ORDER NUMBER
C-2-25

FortisBC Energy Inc.
Application for a Certificate of Public Convenience and Necessity for the
Okanagan Capacity Mitigation Project

DECISION

Figure 1: 2023 Peak Demand Forecast²⁰

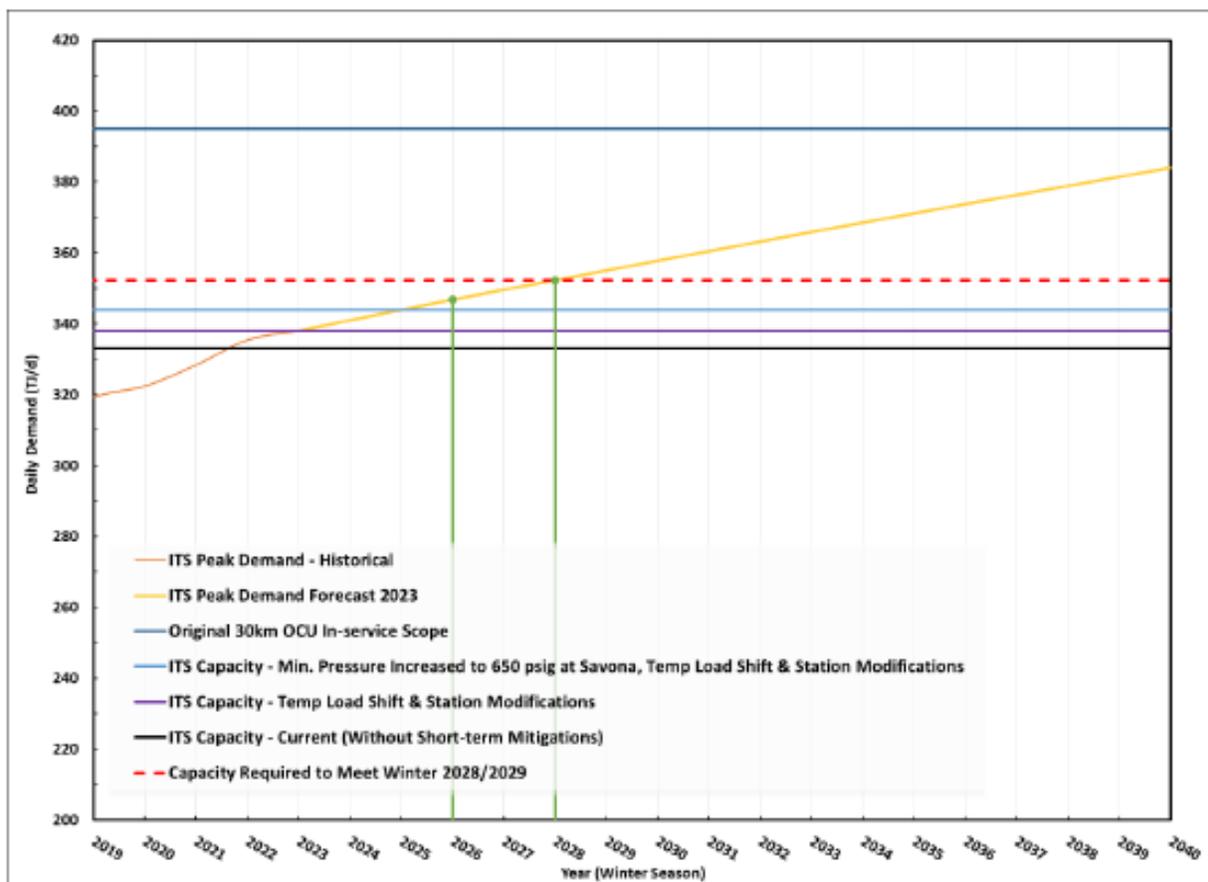
In the OCU proceeding, FEI’s need for the OCU was based on its 2022 Peak Demand Forecast. For this Application, FEI uses an updated 2023 Peak Demand Forecast, which is based on the forecast of customer growth for 2023, and 2022 year-end customer attachment and load data (2022 year-end data).¹⁸ FEI states that the 2023 Peak Demand Forecast, shown in Figure 1 below, confirms the potential capacity shortfall on the ITS by winter 2026/2027 that cannot be addressed with short-term mitigation measures (discussed in the following subsection) already implemented. FEI states that, since the OCMP addresses near-term needs (through winter 2028/2029), it considers the 2023 Peak Demand Forecast reasonable for defining the scope of the OCMP.¹⁹
